SUBJECT: Response to NRC Questions Regarding Acceptability of Waterford 3 Steam
Generator Degraded Batwings
Waterford Steam Electric Station, Unit 3
Docket No. 50-382
License No. NPF-38

**Non-Proprietary Copy of Response to NRC Questions
Regarding Acceptability of Waterford 3 Steam Generator Degraded Batwings**

Subject: **Response to NRC Questions Regarding Acceptability of Degraded Waterford Batwings**

Figure 1
Wrap-Around Bar and Shroud Geometry

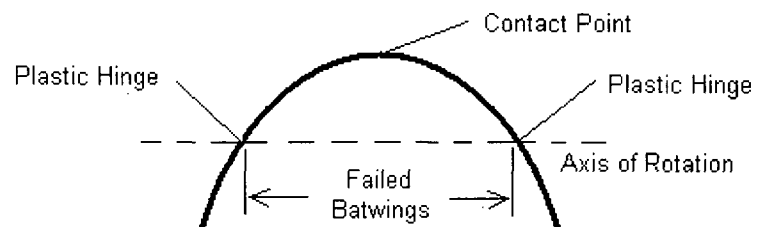
The purpose of this document is to discuss the potential for contact between the wrap-around bar and the shroud as a result of broken batwings in the central cavity region. Evaluations in the reference found that each broken batwing may apply a moment to the wrap-around bar up to 200 in-lbs. The cumulative effect of twenty adjacent broken batwings was shown to cause torsional and bending stresses approaching the yield strength in the wrap-around bar. The sense of the applied loads is to twist the wrap-around bar away from the tubes and toward the shroud. A larger postulated number of adjacent broken batwings results stresses greater than the material yield strength, eventually leading to the formation of two plastic hinges in the wrap-around bar. At this point large deformations of the wrap-around bar are possible. These deformations can be large enough to result in contact between the wrap-around bar and the shroud.

The top sketch in Figure 1 shows a section view of the shroud with the wrap-around bar projected into the plane of the section. The significant dimensions of the shroud and wrap-around bar are shown including the radius to the ID of the shroud and the elevations of the top (or apex) of the wrap-around bar and the bottom of the shroud cone. This sketch shows the hypothetical location for plastic hinges in the wrap-around bar. The dashed line represents the deformation of the wrap-around bar subsequent to the formation of the plastic hinges resulting to contact with the shroud.

The lower sketch in this figure shows a view normal to the plane of the wrap-around bar and indicates the location of the plastic hinges and the contact point with the shroud. In this sketch all batwings between the plastic hinge points are postulated to be broken in the central cavity. Further analysis shows that contact with the shroud will occur if the plastic hinges form 4 inches or more below the apex of the wrap-around bar; that is, if the rise between the axis of rotation and the apex of the bar as shown in the lower sketch is at least 4 inches. This corresponds to approximately 38 broken batwings between the plastic hinge locations. In other words, if more than 38 adjacent failed batwings are required to cause plastic hinges in the wrap-around bar, the projection of the bar above the axis of rotation would be long enough to result in contact with the shroud. If less than 38 are required, contact would not be expected.

Based on the conservative analysis reported in the Reference, it would be expected that plastic hinges would form with slightly fewer than 38 adjacent failed batwings. Therefore, the assumption that each failed batwing exerts a 200 in-lb moment on the wrap-around bar leads to the conclusion that contact between the bar and the shroud would be unlikely.

This leads to the conclusion that significantly more than 20 broken batwings are required to initiate plastic deformation of the wrap-around bar and more than 38 broken batwings will be required to develop plastic hinges in order to initiate contact with the shroud. Thus, contact between the wrap-around bar and the shroud is considered to be possible under ideal conditions, but not likely due to the conservatism involved with the analysis.
